PAGEWOOD GREEN STAGE 2 MASTER PLAN
PLANNING PROPOSAL

PEER REVIEW

Prepared for Bayside Council by

In July 2017 Hill Thalys was engaged by Bayside Council to assess Meriton's revised master plan for Pagewood Green Stage 2 (referred to in this document as "**Revised Proposal**"). This follows earlier work undertaken by Hill Thalys to produce a comprehensive Urban Design Study for the site in 2016.

4.10 SOLAR ACCESS AND OVERSHADOWING

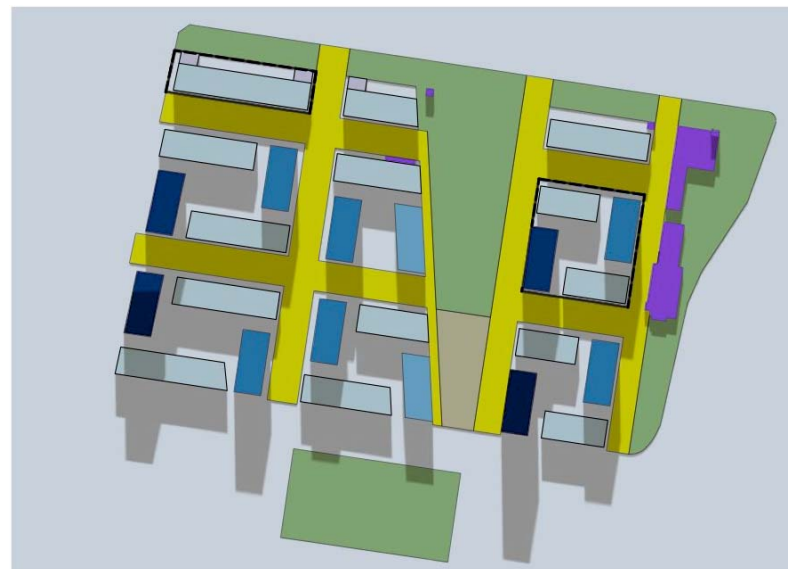
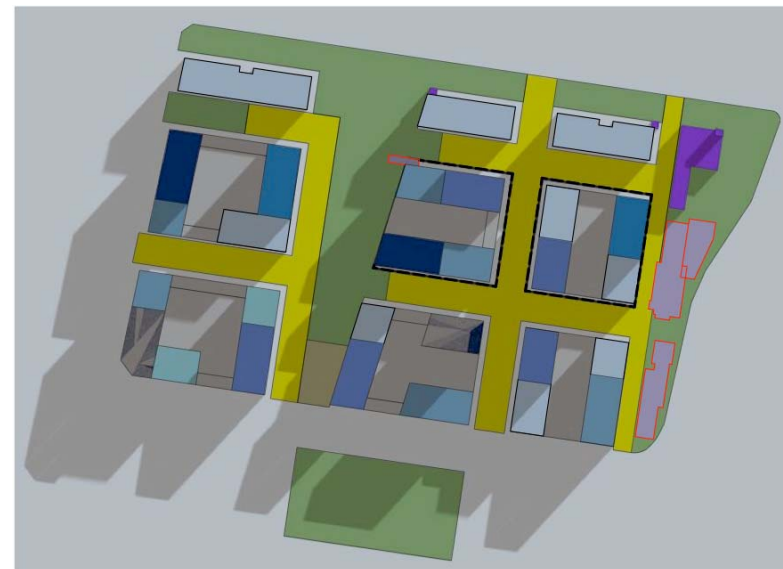
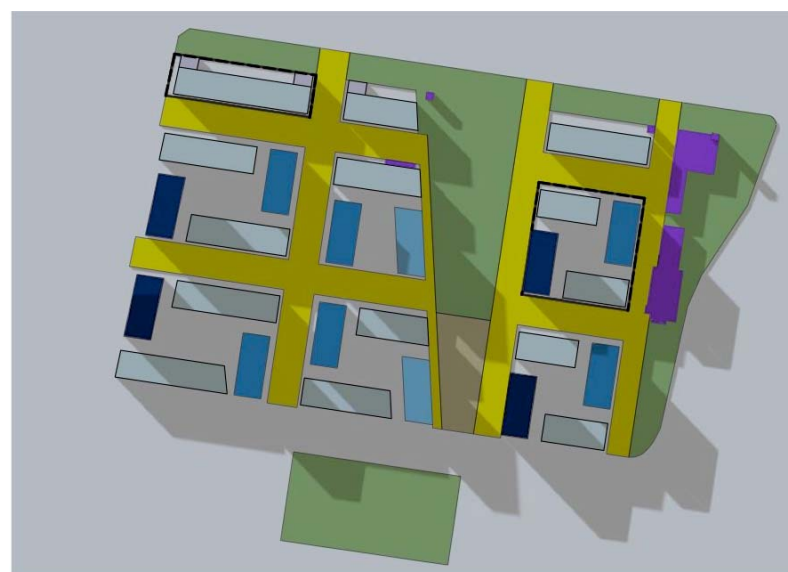
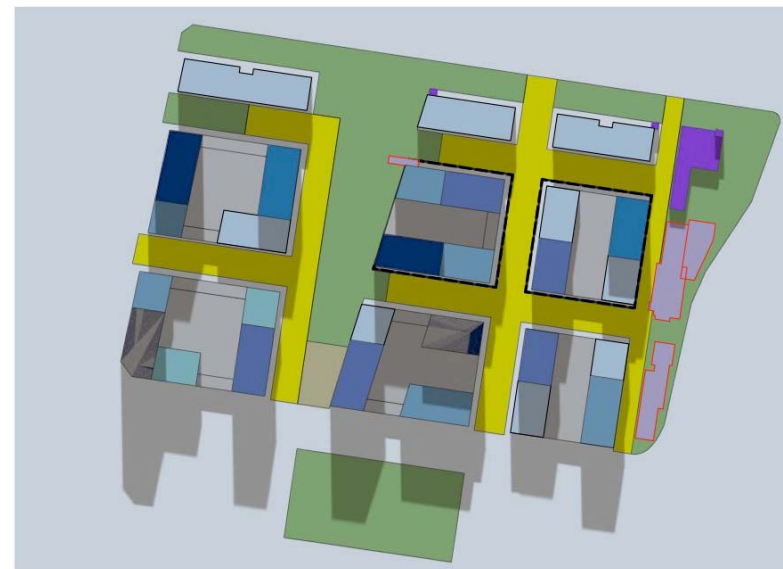
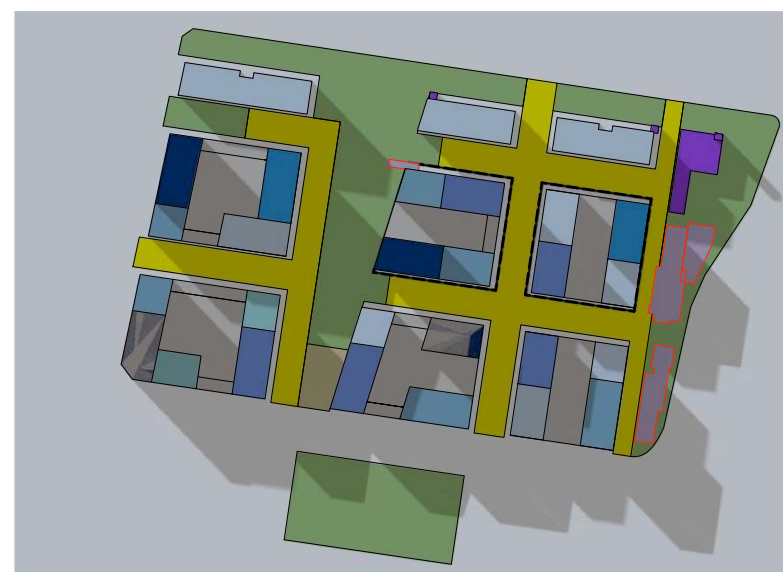
The built form proposed in the Revised Proposal shows significantly increased over-shadowing impacts on the central park, streets and adjacent park in stage 1 to the south.

This increase in overshadowing should be mitigated by providing an orientation such as that in the Draft Council Master Plan.
